Final reply to Referee 2's review of the AMTD paper

” Detailed characterisation of AVHRR global cloud detection performance of the CM SAF CLARA-A2 climate data record based on CALIPSO-CALIOP cloud information”

Karl-Göran Karlsson and Nina Håkansson, SMHI

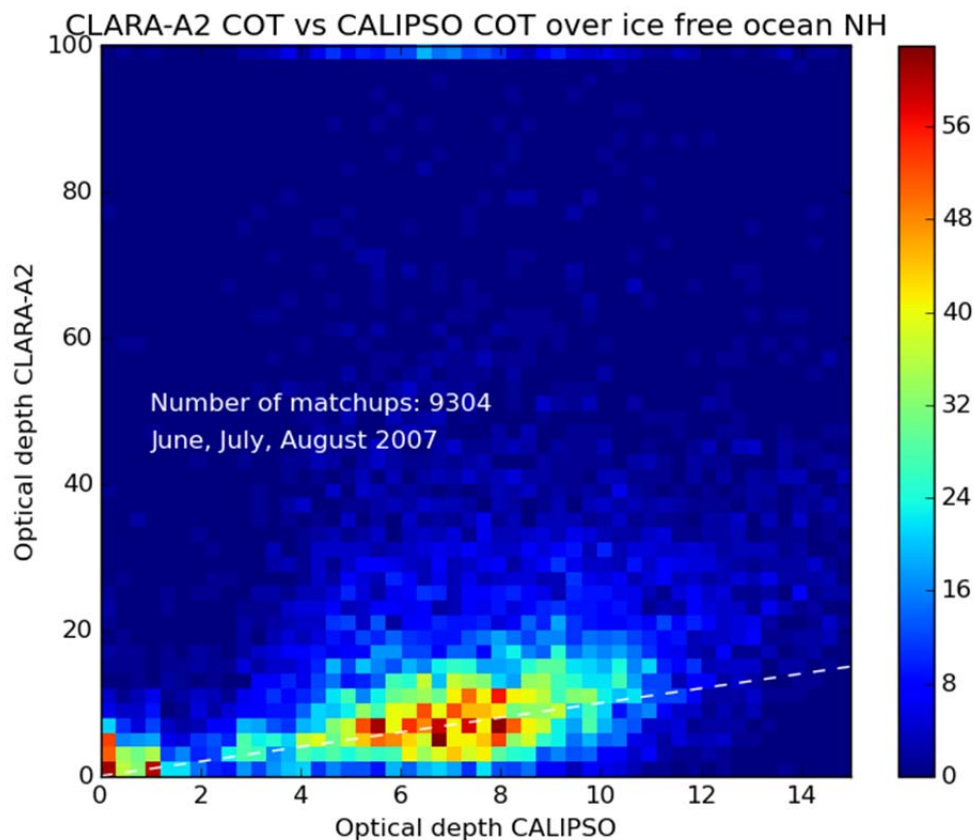
L126-127, “...claiming that useful...seems to be available” - based on which results?

(2017) we investigated the correlation between CALIPSO-estimated and CLARA-A2 estimated CODs over various surfaces (with snow surfaces over Greenland as the main target). However, when isolating the collocated results over ice free ocean surfaces at high latitudes (noting that over a dark surface also the AVHRR-based estimations should be more accurate), we could clearly see a good correlation between the two estimations up to about COD=5 (see figure below):

Although this is not a perfect illustration (not included in Riihelä et al, 2017, but maybe considered for a follow-up paper) it shows how CLARA-A2-estimated optical depths compare to CALIOP-estimated optical depths in the range 0-15. Over a dark ocean surface the majority of values agree pretty well but what is clear is that an increasing number of cases (for higher optical depths) CLARA-A2 values saturates at 100 for CALIOP-values exceeding approximately 4 (noticeable at top of the figure). This reflects the inability of CALIOP to provide reasonable optical thicknesses for optically thick clouds. But, we made the conclusion that values compare pretty well even up to an optical thickness of 4-5 and this was one of the reasons why we decided to use the CALIOP interval 0-5 for this particular study (for AMT).

We propose that we keep the original maximum value of 5 in our plots but add a remark that values near this upper end are uncertain (lines 146-154). The upper limit is not crucial for the findings of our study since in most cases the cloud detection sensitivity is considerably lower than 5. Only for some positions over Greenland and Antarctica we approach these high values but whether the value is 3 or 5 here does not really matter since it deviates anyhow very much from the values found on other places (which is the main message).

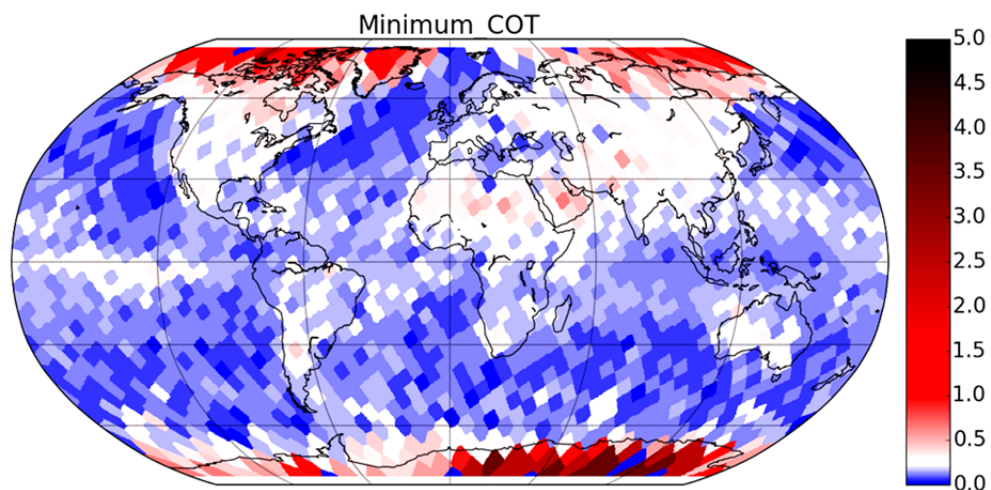
Figure 11, it would be useful to have a different color scale (e.g. as in previous figures), with a shift between colours at 0.225. Otherwise it is difficult to see the ‘edge’ at 0.225

Reply: We definitely agree. This was one of the changes we had planned even before achieving review comments to the discussion paper. Here is our proposed new Figure 1 with blue colours denoting places where the detection sensitivity value is lower than the average value of 0.225 and where red colours show places where values are higher than the average. This new plot is also better in showing the high values over the poles (which were just masked out in grey colours in the previous figure).
